We are residents of 394 Brayton Road Marulan situated approx 1.5kms **SOUTH-EAST** of the proposed Pit Extension site, approx 2kms **SOUTH-EAST** of Gunlake Quarry Approved Pit, approx 2kms **NORTH-EAST** of the Holcim Australia Lynwood Quarry Approved Pit, approx 1.9kms **EAST** of the Lynwood Quarry Modification 4 Granite Pit site and approx 700 metres **SOUTH** of Holcim Australia Johnniefelds Quarry. We are identified as Receptor Location 8 of the Air Quality assessment locations (Figure 12.1) in the Environmental Impact Statement (EIS) Main Report. We are in close proximity to, and surrounded by, a large section of the quarrying industry in Marulan and, in addition to this, are approx 2.7kms **WEST** of the Hume Highway. Our location makes us vulnerable to the cumulative impacts of noise, dust, traffic and transportation generated by the operations of this industry and respectfully request that the Department of Planning & Environment adopts a wholistic approach and takes into consideration other Marulan quarry applications currently before the Department when assessing Gunlake Quarry Mod 4 - Pit Extension (Mod 4).

In submitting our objection to the Gunlake Quarry Mod 4, we w

Figure 4-1: Annual Average Wind Rose - Quarry Station - 2014

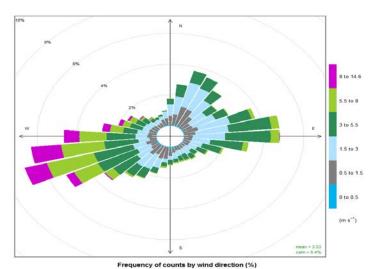
Fact: Figure 4.1 of the Air Quality EA below shows wind speed and direction data recorded by the onsite meteorolgical monitoring station at Gunlake Quarry. In contrast to the windrose data from Gunlake Quarry is that of the Lynwood Quarry meteorological station for the same period 2014-2015 (See Attachment C). In October 2015, Pacific Environment Limited interpreted the Lynwood data as showing the predominant wind directions as being from the west, particularly in winter, with smaller contributions from the west-south-west and west-north-west. The strongest winds were from the west with the annual average wind speed being 3.7m/s and calm days amounting to 2.9%. With such differing data from the two quarry weather stations in such close proximity to each other, further investigation is required to establish the accuracy of each.
